Backfeed Adhoc

7 May 2018

Backfeed voltage ... a closer look (single-signature PD)

Figure 3. Typical Reverse Current

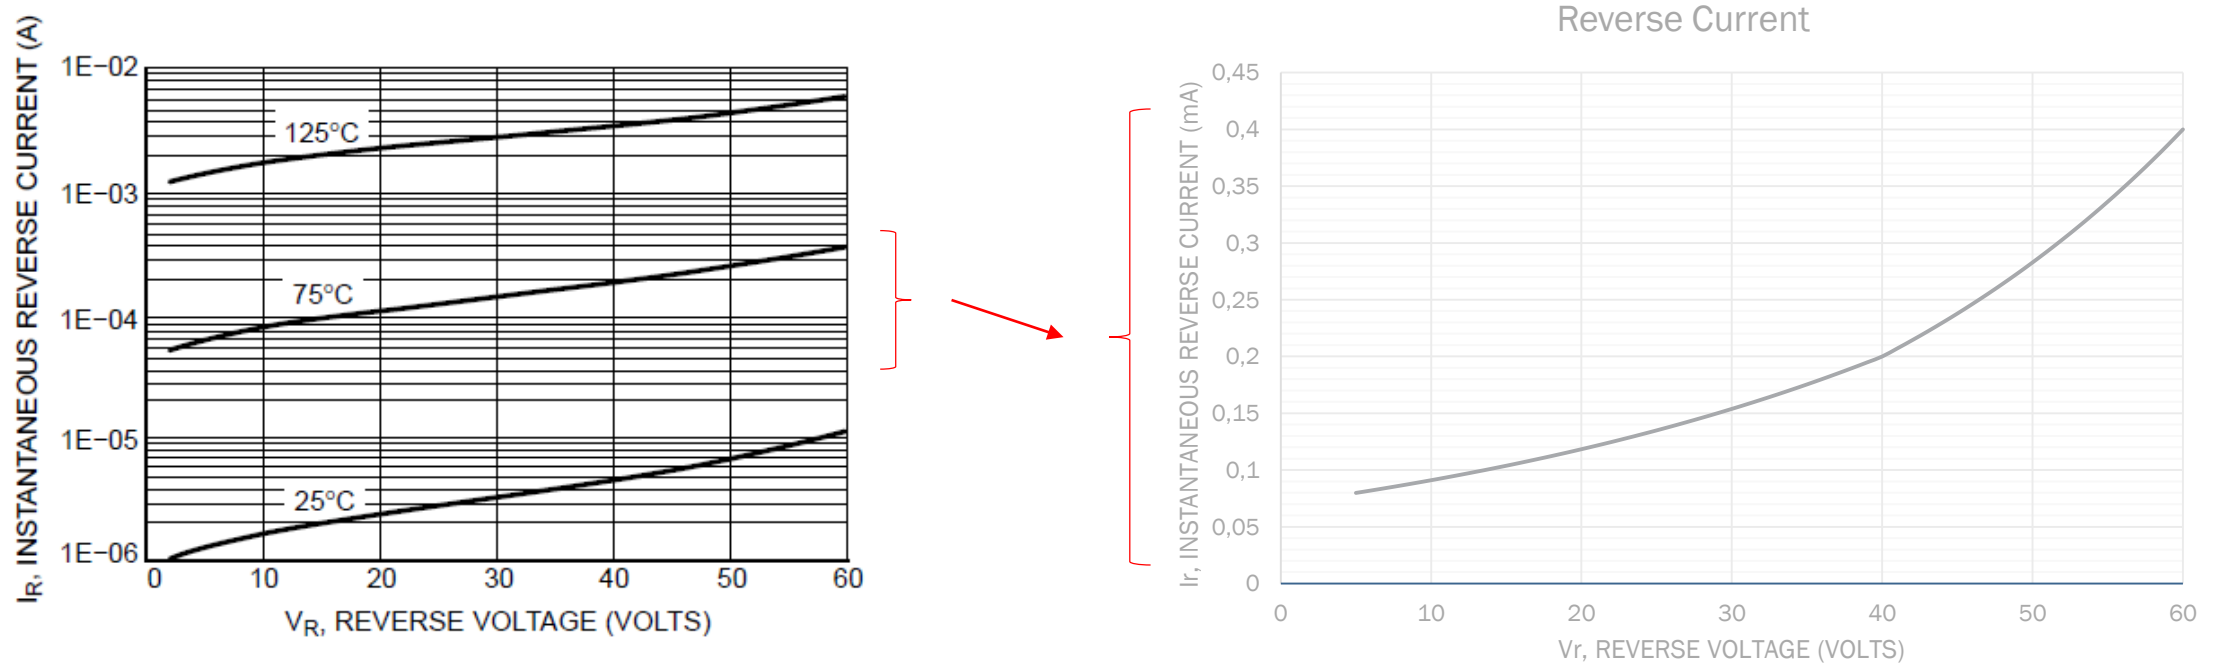
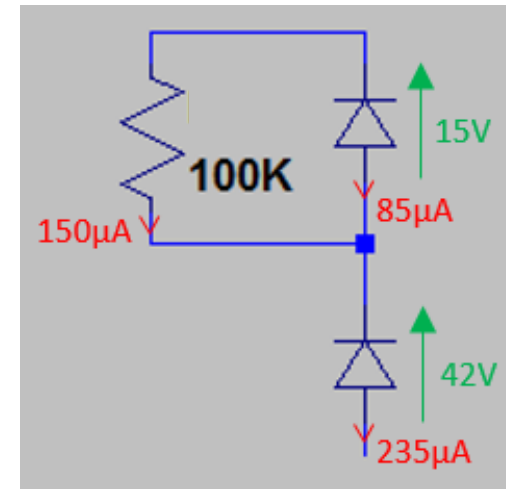
The temperature of the diode bridge on the unpowered pairset will be close to the lead temperature of the diodes conducting the current on the powered pairset.

A lead temperature around 65 °C corresponds to a common operating condition (the same temperature is used to specify the max cable DCR – see 145C.3)

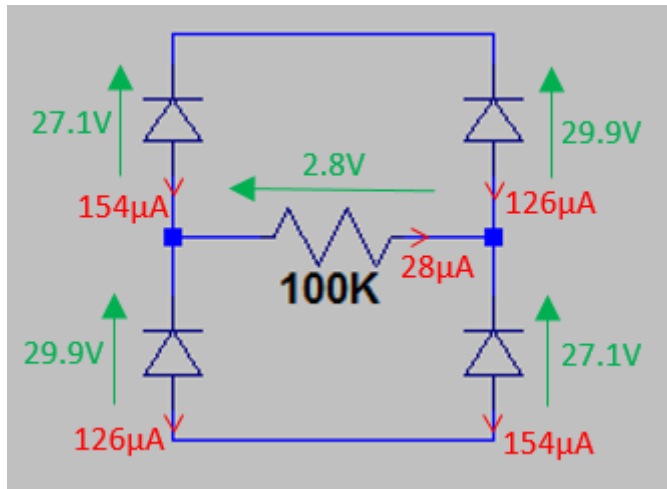
When extending the existing 'symmetrical' backfeed voltage specification to an 'asymmetrical' 3P reflected voltage specification, a significantly larger reflected voltage value can be expected even with PDs using real diode bridges.

Moreover when introducing a backfeed/reflected current specification and furthermore reducing the 100kΩ down to 0 Ω, much larger backfeed/reflected currents than 28μA ($2.8\text{V}/100\text{k}\Omega$) can be expected (e.g. $360\mu\text{A}@57\text{V}$).

The 2P overall schematic (on the left) versus the new 3P overall schematic(s) (on the right).

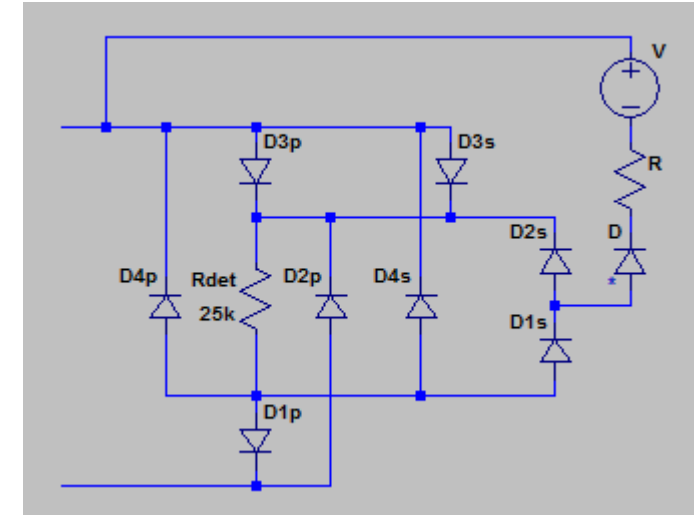
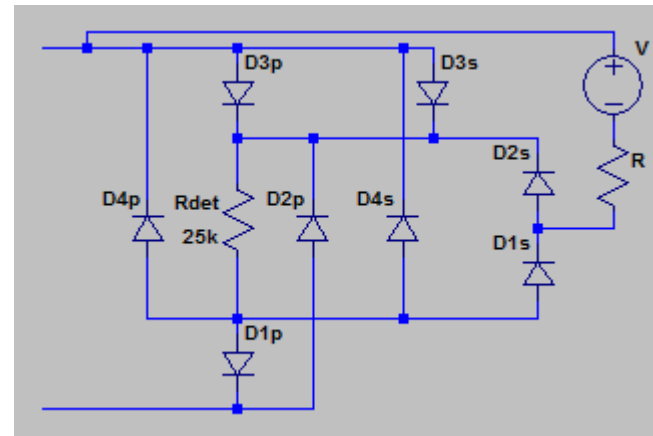
The Schottky diode DC leakage current is usually overlooked !

What should be the V , R and (optional?) D for the other mode of the “3P PSE” ?

(... if any combination is possible anyhow allowing a “3P PSE”)
